DUKE POWER COMPANY  
OCONEE NUCLEAR STATION  
ATTACHMENT 1a  
IMPROVED TECHNICAL SPECIFICATIONS

This proposed amendment revises the pressure-temperature limits of Improved Technical Specification (ITS) 3.4.1 and Current Technical Specification (CTS) 3.1.2 for Oconee Units 1, 2, and 3. The proposed amendment will revise the heatup, cooldown, and inservice test limitations for the reactor coolant system of each unit. For Units 1, 2, and 3, the current pressure-temperature limits are established to 21, 19, and 21 effective full power years (EFPY), respectively. The service period for the new pressure temperature limits will be to a maximum of 26 EFPY for Units 1, 2 and 3.

Figure 3.4.3-7 (page 1 of 1)  
RCS Normal Operational Heatup Limitations  
Applicable for the First 23 EFY - Oconee Nuclear Station Unit 3

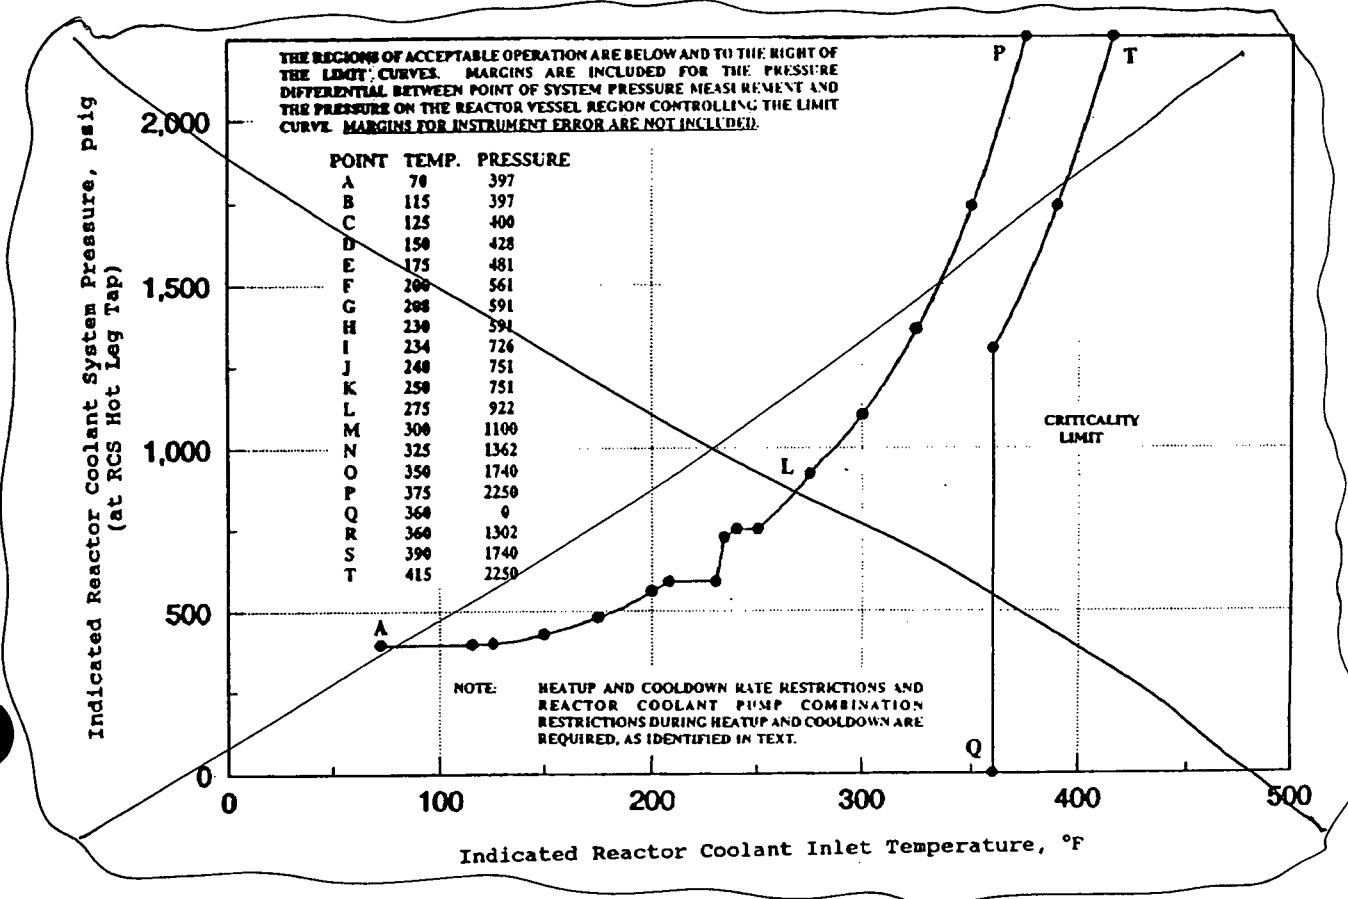
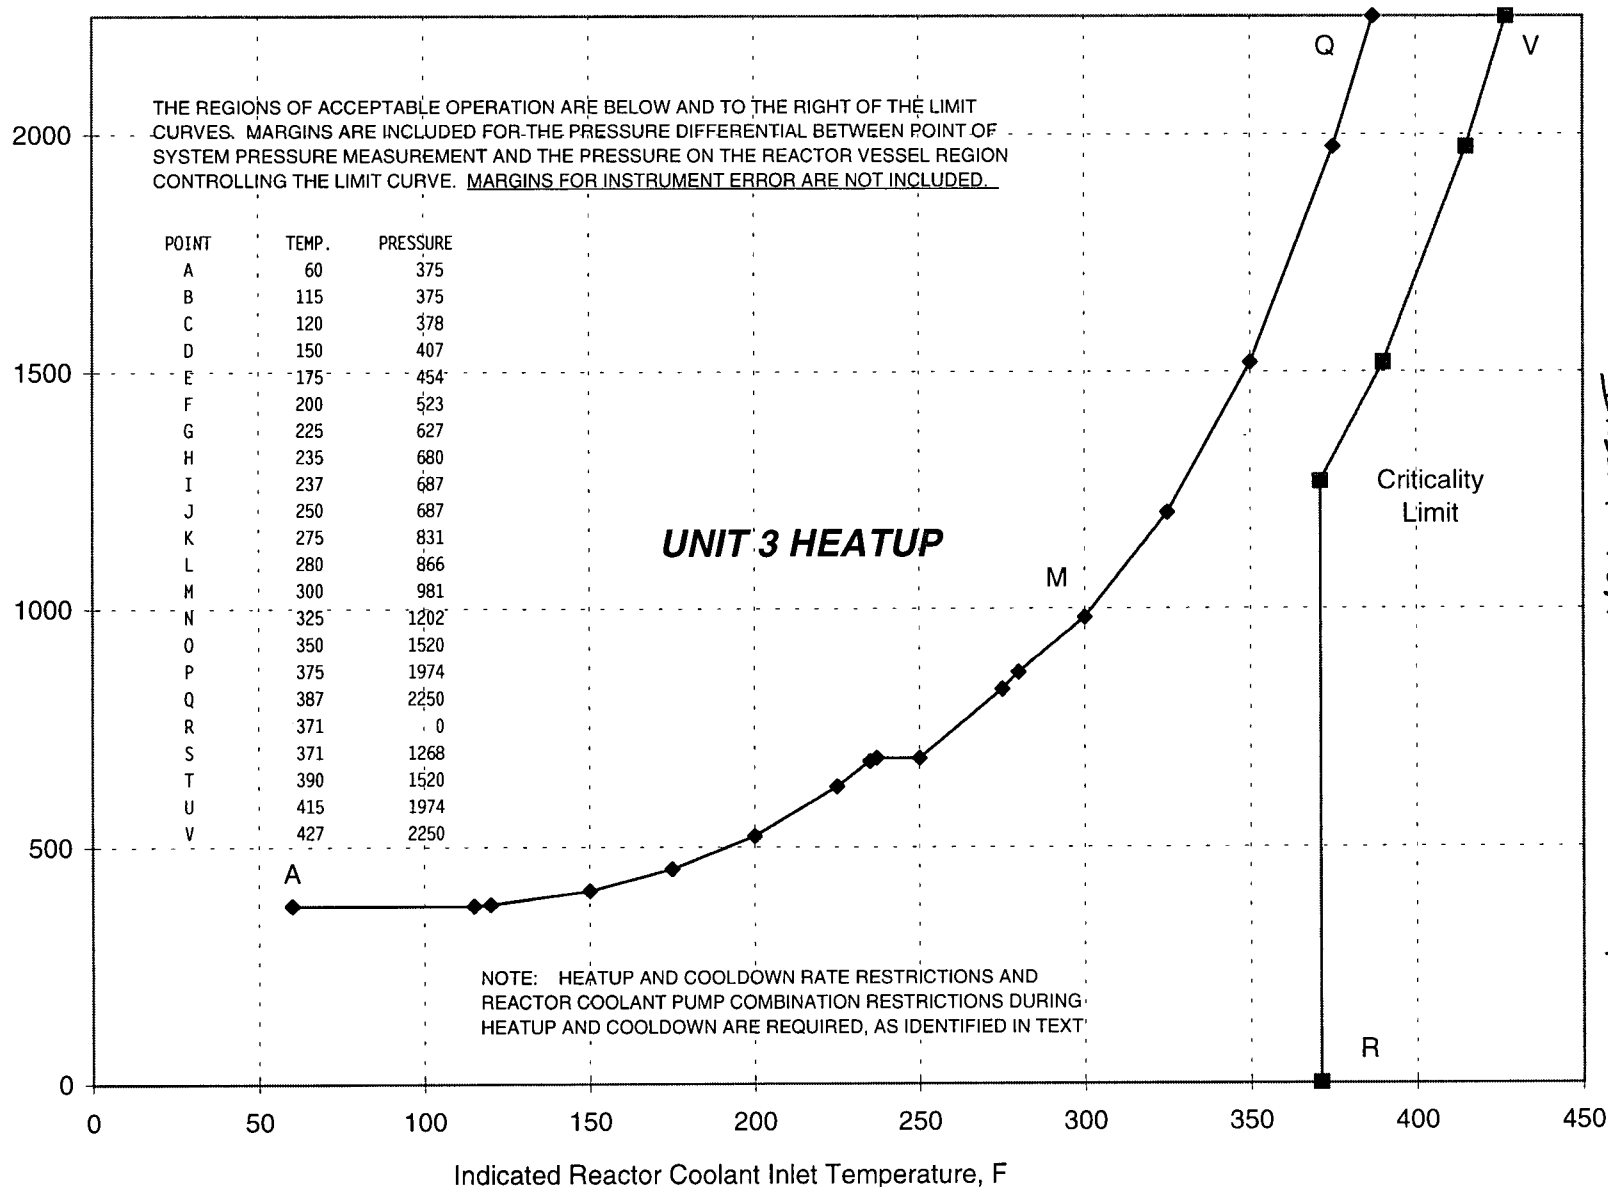
INSERT REVISED FIGURE

INSET FOR FIGURE 3.4.3-7

Figure 3.4.3-8 (page 1 of 1)  
RCS Normal Operational Cooldown Limitations  
Applicable for the First 21 EFY - Oconee Nuclear Station Unit 3

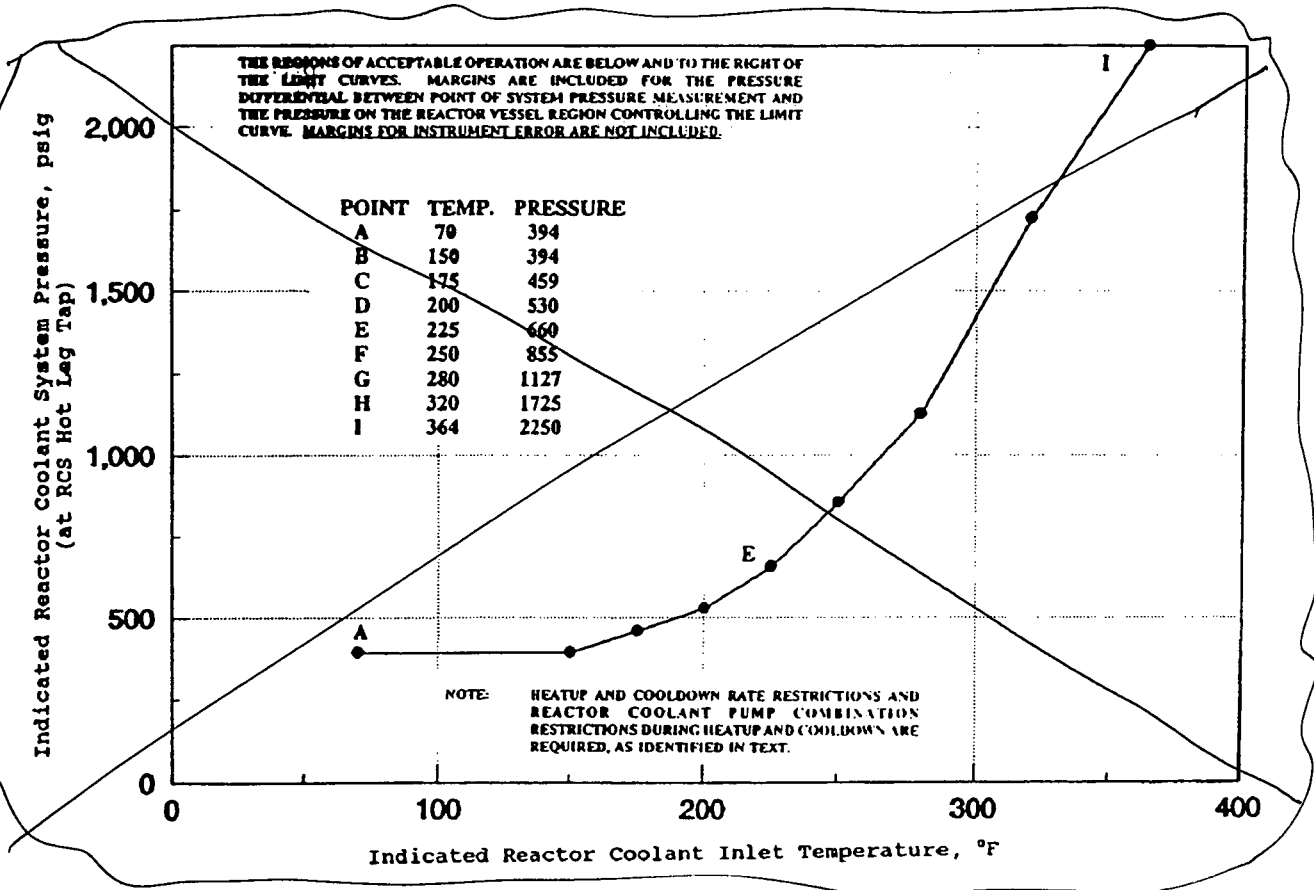
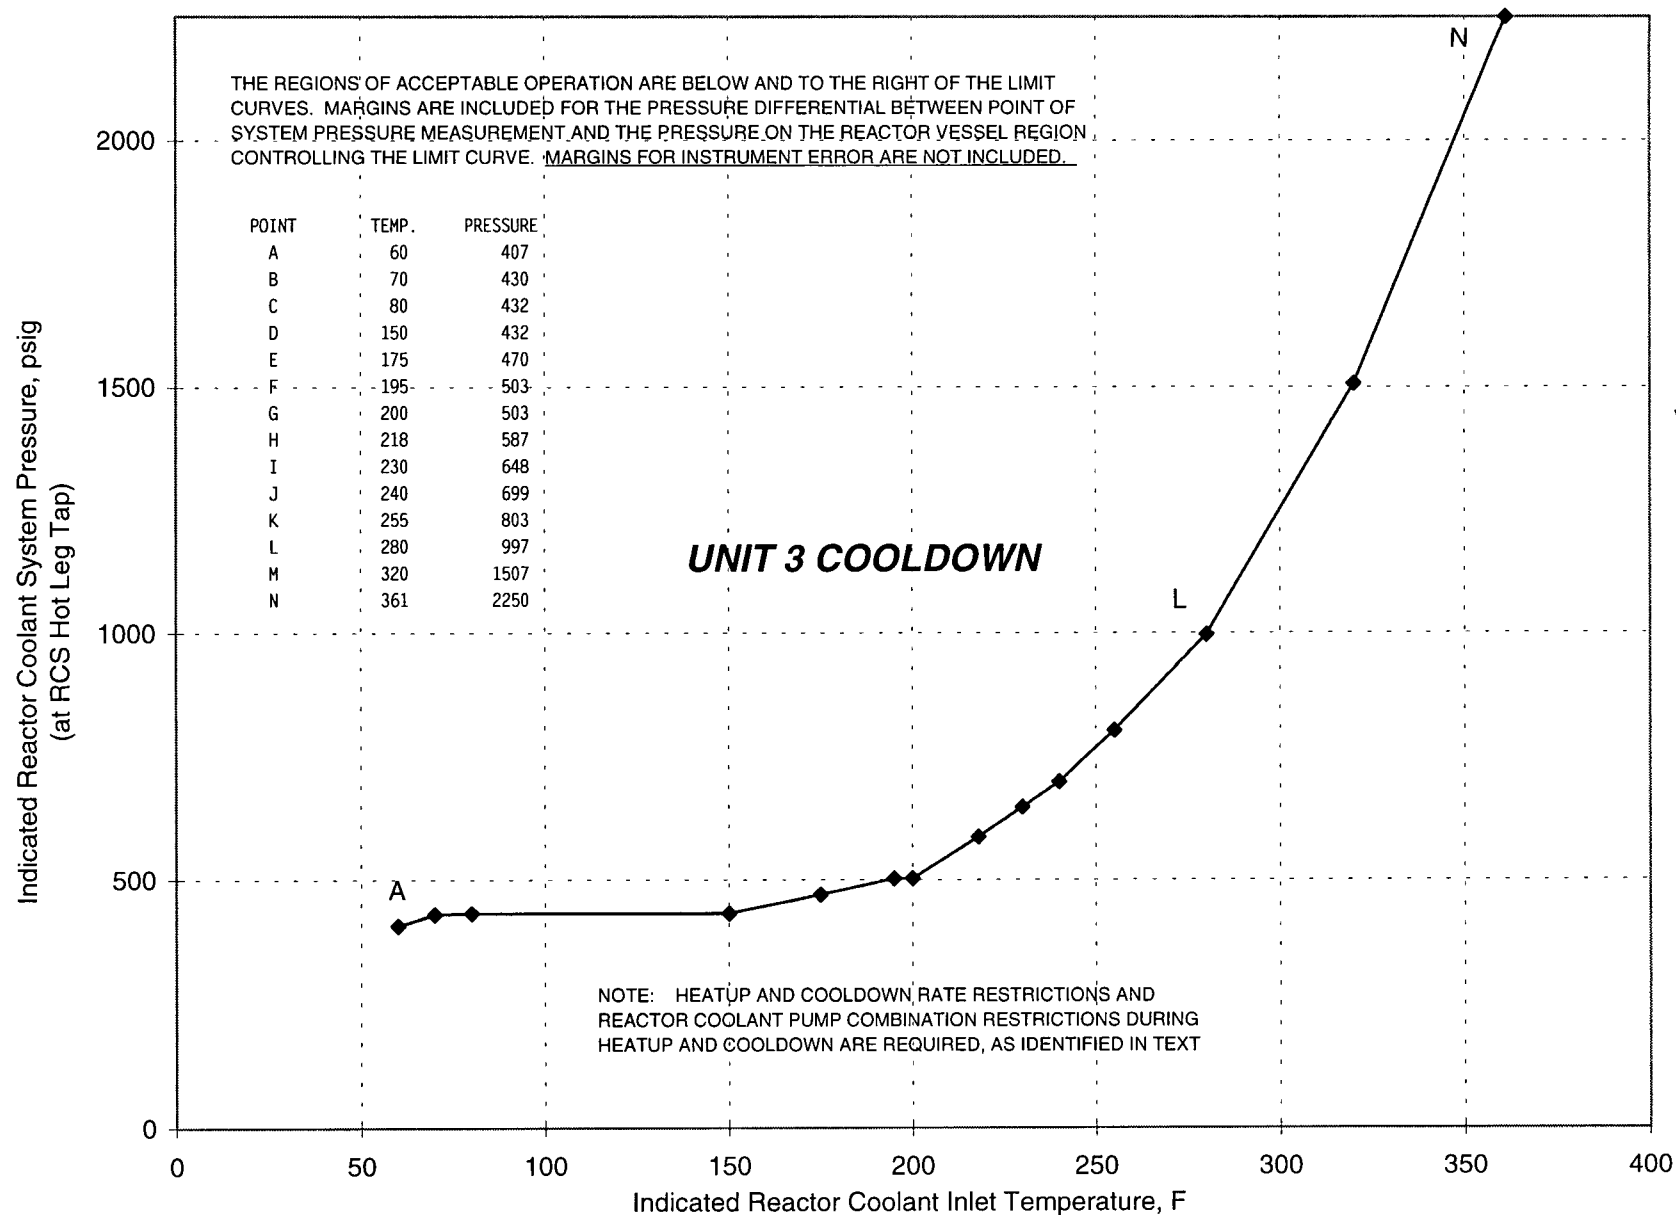
INSERT REVISED FIGURE

INSERT FOR FIGURE 3.4.3-B

Figure 3.4.3-9 (page 1 of 1)  
RCS Leak and Hydrostatic Test Heatup and Cooldown Limitations  
Applicable for the First 21 EFY - Oconee Nuclear Station Unit 3

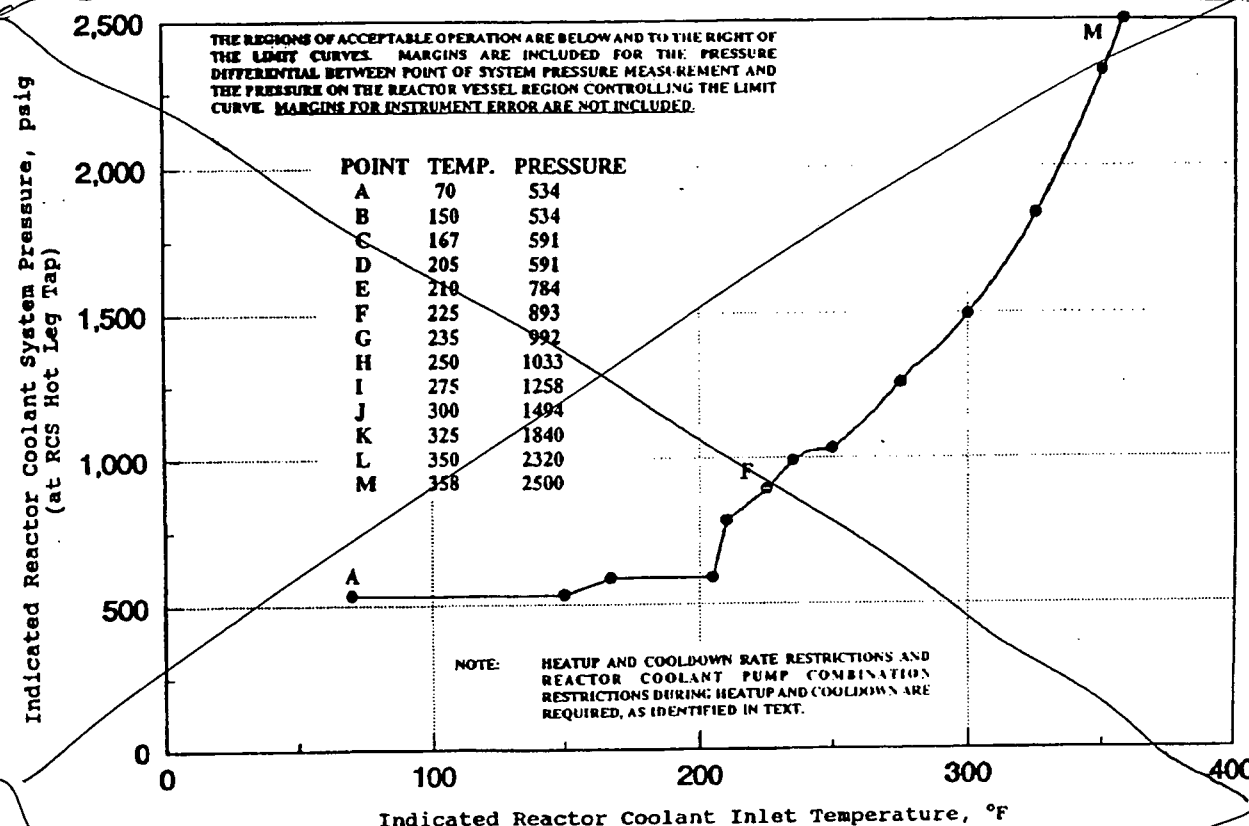
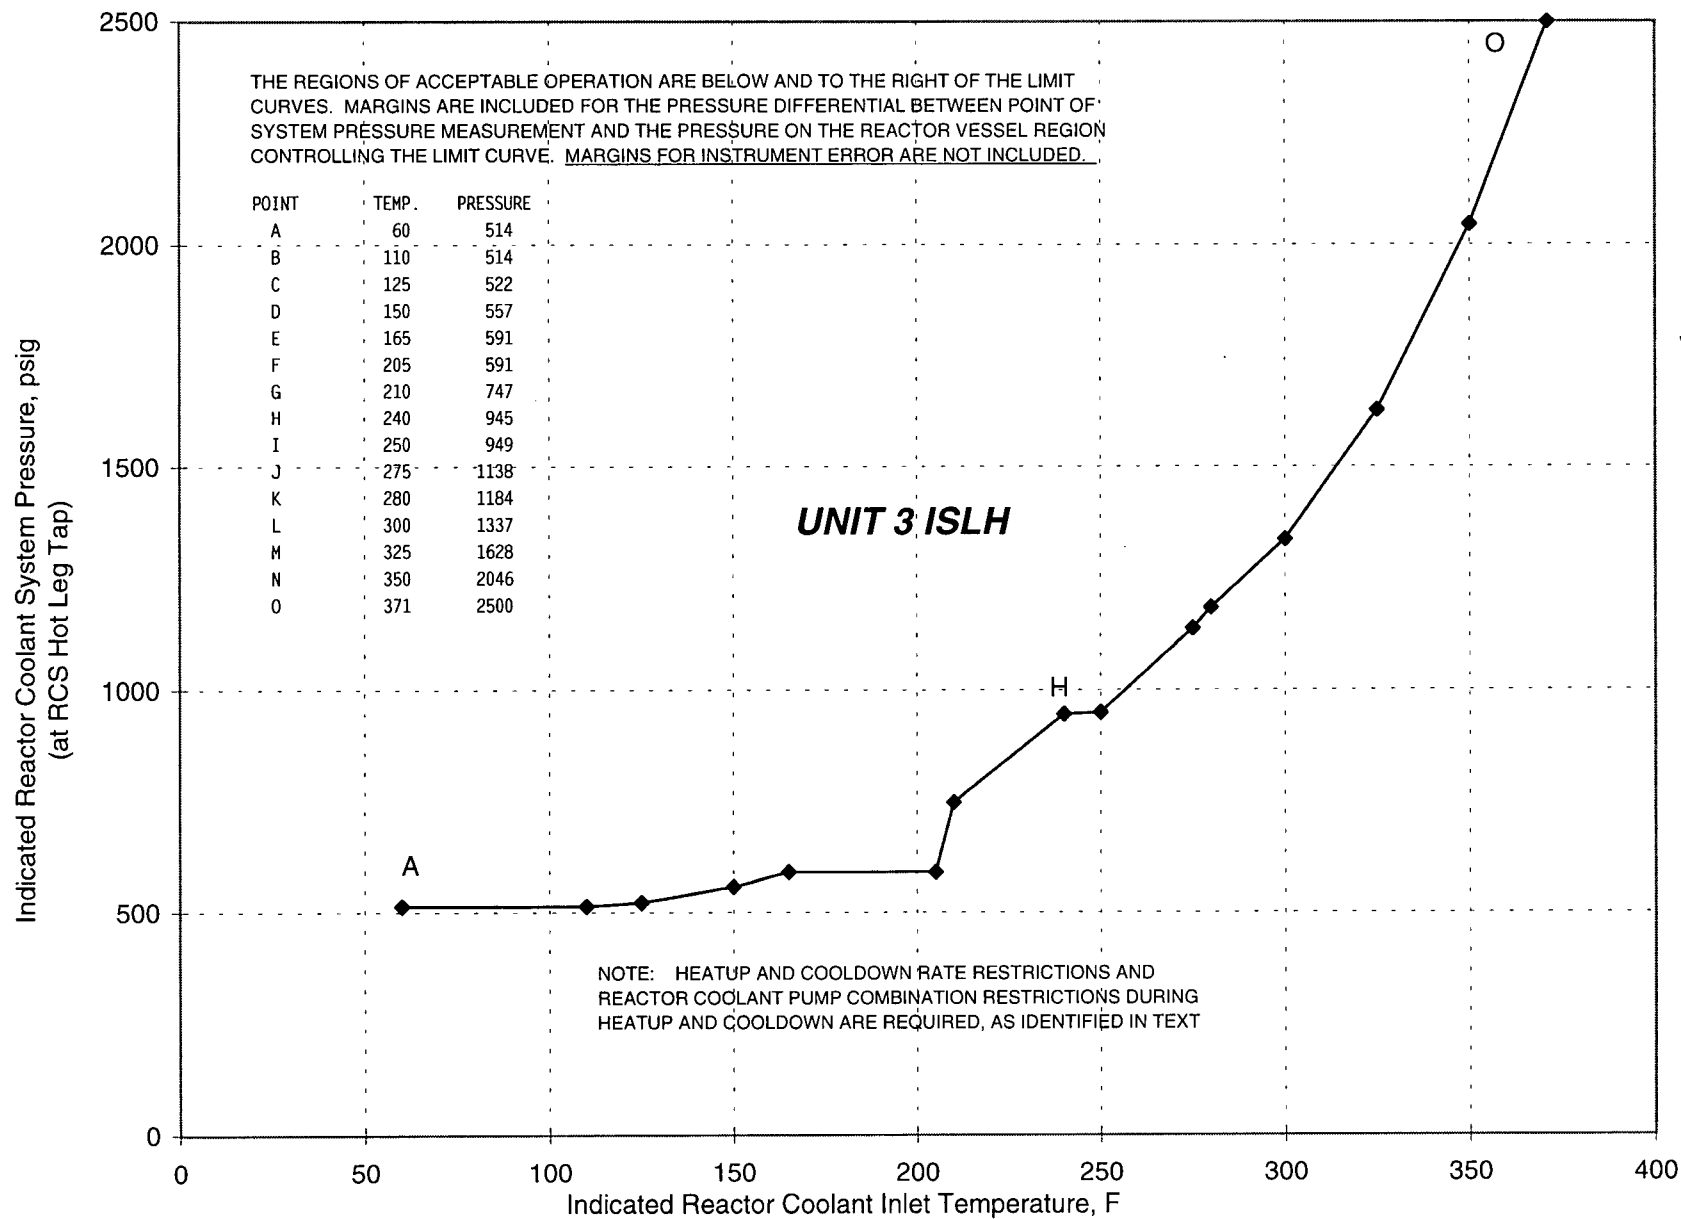
# INSERT REVISED FIGURE

INSERT FOR FIGURE 3.4.3-9
